Planning Commission Meeting Agenda

7.I. (PUD1901-02) Sheldon Crossing Phase 2 Final Development Plan, L&V Development Co., 3373 Busch Dr., Is Requesting Final Development Plan Approval For Phase 2, On A Parcel Of Land Described As P.P. # 70-14-21-300-132, Located At 3045 Port Sheldon St., Georgetown Township, Ottawa County, Michigan.

REQUEST

(PUD1901-02) Sheldon Crossing Phase 2 Final Development Plan, L&V Development Co., 3373 Busch Dr., is requesting final development plan approval for phase 2, on a parcel of land described as P.P. # 70-14-21-300-132, located at 3045 Port Sheldon St., Georgetown Township, Ottawa County, Michigan.

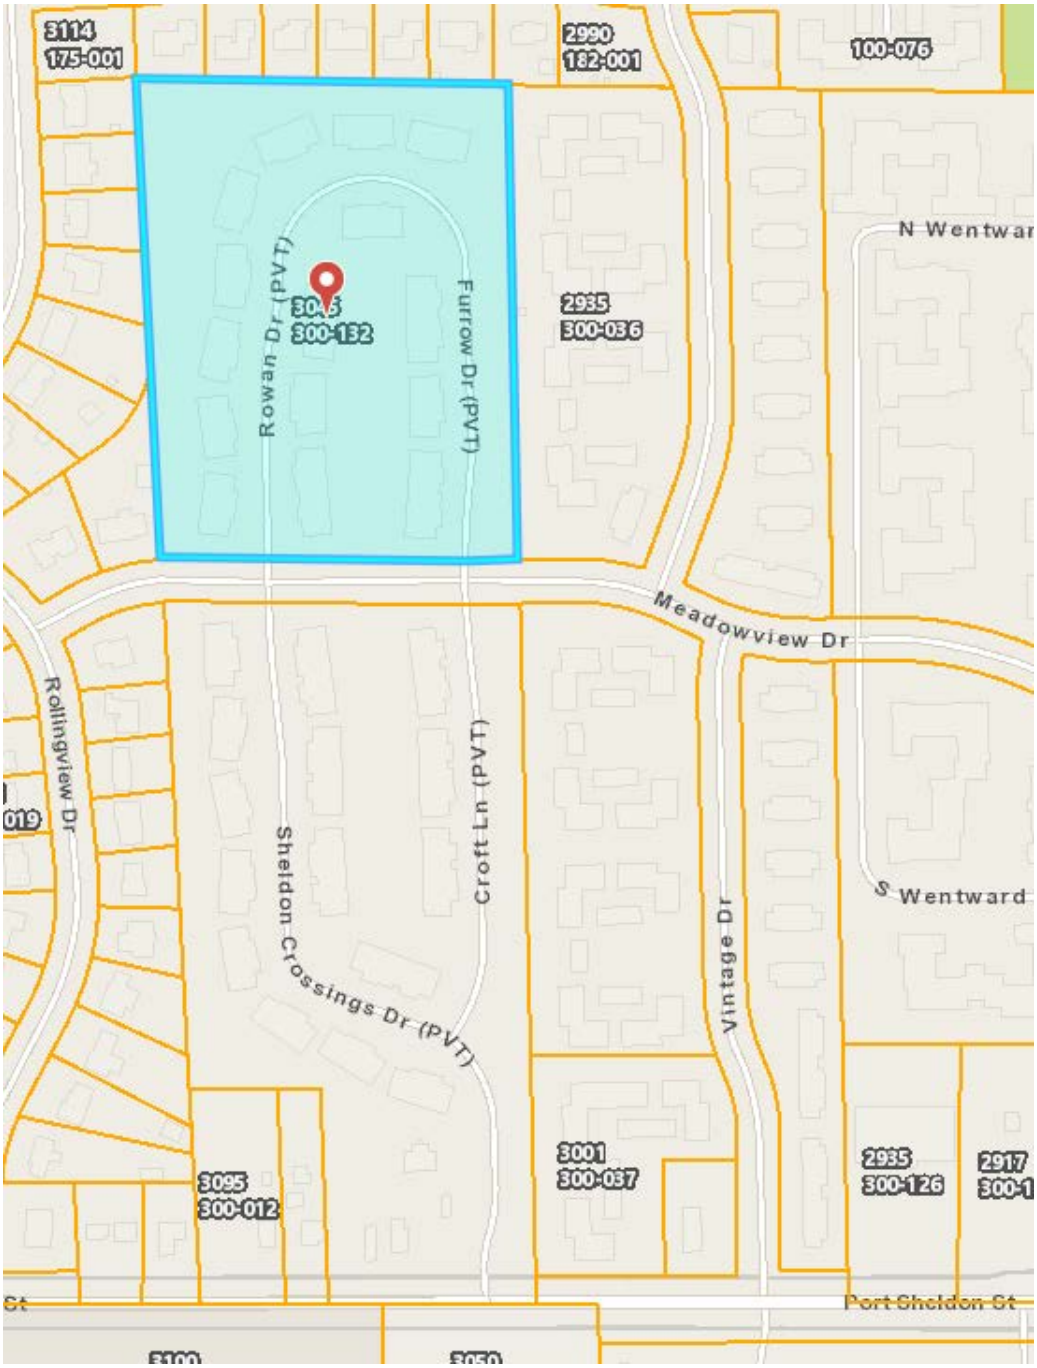
The request is for a final development plan approval for phase 2 of Sheldon Crossings 21.5 acres for 15 condominim buildings with a total of 34 units. The proposal calls for 7 acres of open space overall. The plan shows Meadowview Drive connecting from the west side of the property to the east side. The rest of the streets are proposed to be private.

The following is the Future Land Use Map related to the proposed PUD development.

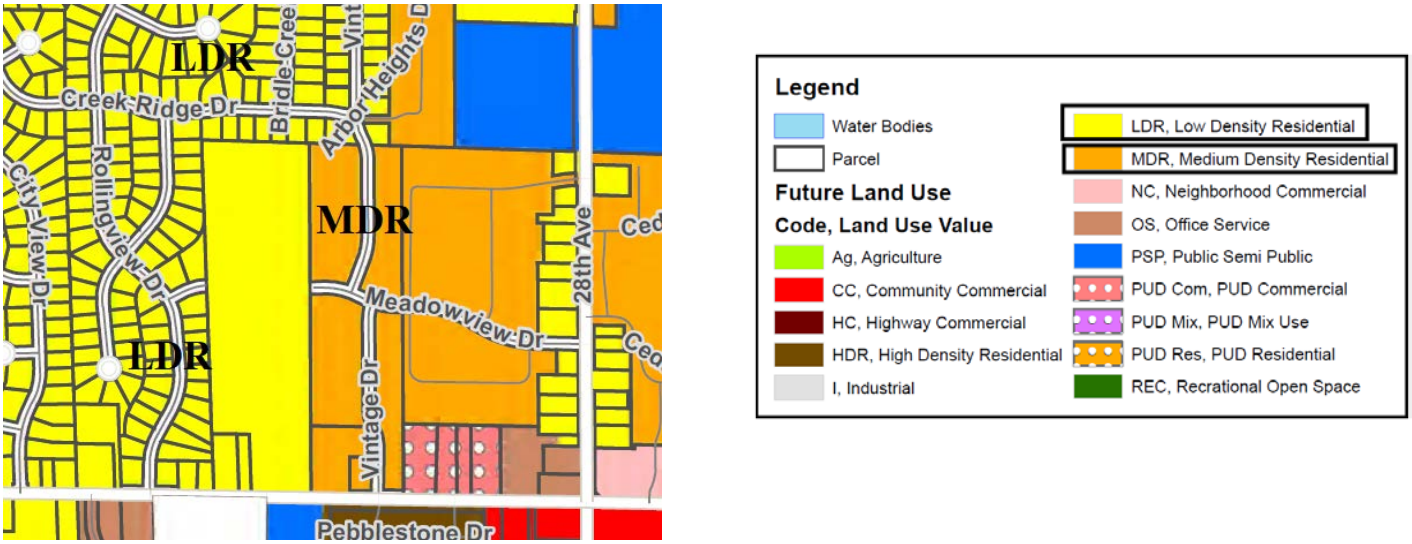
The proposal appears to be consistent with the text and Future Land Use Map in regard to the uses and the density. The Future Land Use Map shows the area as LDR. The plan proposes 3.3 units per acre which is close to being consistent with an overall density of 3 units per acre which meets the intention of page 36 in the Master Plan. Further, page 35 of the Master Plan states the following and the property to the east is designated Medium Density Residential.

Page 35
<u>It is noted that lines separating land use categories are NOT to be considered to be defined lines and the lines are not necessarily parcel specific</u>.

SITE DEVELOPMENT PLAN – SHELDON CROSSING – PHASE 2
FOR: L & V DEVELOPMENT CO.
ATTN: LARRY KERKSTRA
3373 BUSCH DRIVE
GRANDVILLE, MI 49418
IN: PART OF THE SW 1/4 OF SECTION 21, T6N, R13W
GEORGETOWN TOWNSHIP, OTTAWA COUNTY, MICHIGAN

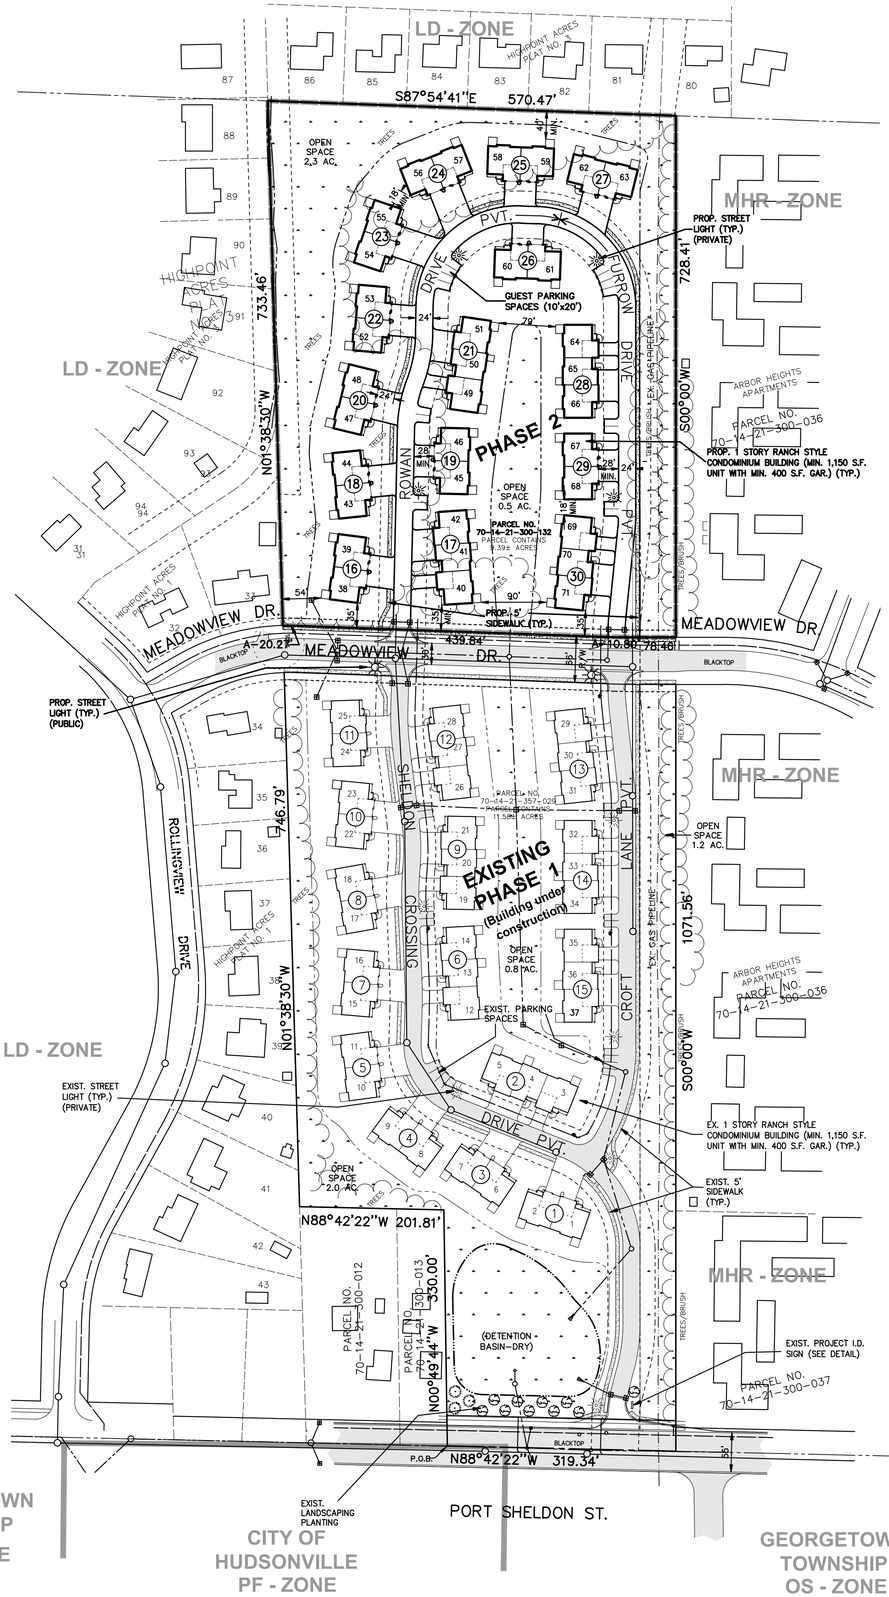
1. **Attached dwellings**. In the current LDR zoning, single family houses are allowed and attached dwelling units are not allowed. They are allowed in the higher density residential districts only (unless in a PUD). The plan proposes 30 condominium buildings with a total of 71 total units. Of the 21.5 acres, 7 acres is proposed to be open space, which exceeds the 20% minimum. For the 21.5 acres used in the density computation, with 3 units allowed per acre as per the Master Plan, 64 total units are allowed and the plan proposes 71. That is 7 more units than allowed per the Master Plan density. However, the narrative notes this area is a transition from the LDR to the west and the medium/high density residential area. Note also that the Master Plan is not intended to be parcel specific, but rather the lines should be considered to be wider. The Planning Commission will have to determine if the 11% additional units meet the intention of the Master Plan and if they should be allowed.

2. **Distance between buildings**. Footnote (j), which is applicable to the MHR district in Chapter 24, requires a minimum of 25 feet between contiguous buildings. The plan proposes a minimum of 18 feet, which is 7 less than the regulatory 25 feet.

3. **Setbacks**. With the current LDR zoning, a minimum front yard setback of 40 feet is required and is to be measured from a point 60 feet from the centerline of Port Sheldon. This is met along Port Sheldon. The plan proposes a minimum of a 35 foot front yard setback north and south of Meadowview Dr. This is 5 feet less than the 40 feet required for the conventional LDR zoning. Side yards are proposed to be a minimum of 50 feet which exceeds the 10 foot required in LDR. The rear along the northern property line is proposed to be 40 feet which meets the current LDR standard.

4. **Sign**. Sec. 25.2(L) defines a plat entry sign as a sign placed as a road entrance to a subdivision, mobile home park or multiple-family development. Since this is a multiple-family development, the plat entry sign is what would be allowed. Sec. 25.6(A)(5) allows plat entry signs as follows: two per road entrance each not exceeding a total area of 64 square feet in area nor 3 feet in height, and setback a minimum of at least 10 feet from 60 feet from the centerline of Port Sheldon (total of 70 feet from the centerline). Only one sign is proposed and is shown as 5.5 feet high (**a deviation of 2.5 feet from the maximum of 3 feet**) and to have 46.75 square feet in area (less than the maximum of 64 square feet allow). The sign is proposed to be located 58 feet from the centerline (**a deviation of 12 feet from the minimum of 70 feet from the centerline**).

A deceleration taper was provided. A left turn lane already exists at the site.

The plan states that 6.8 of the 21.5 acres are open space, which is about 32 of the property and exceeds the minimum amount required. The open space is passive with many sidewalks.

Motion: To adopt the staff report as finding of fact and to approve the final development plan with the previously approved deviations, and with the following conditions:

1. **Each unit shall be a minimum of 1,150 square feet in area with a minimum of 400 square foot attached garage.**

2. **A Storm Water Drain Permit (written approval by the Drain Commissioner's office) shall be submitted to the Township prior to the submission of the first building permit application.**

3. **Utilities are to be coordinated with the DPW and Drain Commissioner's office.**

4. **As per Sec. 22.11, a recorded PUD agreement shall be submitted to the Township prior to the submission of the first building permit application, as noted on the plan.**

5. **Approved permits are required for all signs and all signs shall meet the details listed in the submittal documents or in the ordinance standards.**

6. **If not already installed, as per language noted on the plan, the developer is voluntarily providing the deceleration taper lane to be constructed as per Ottawa County Road Commission standards.**
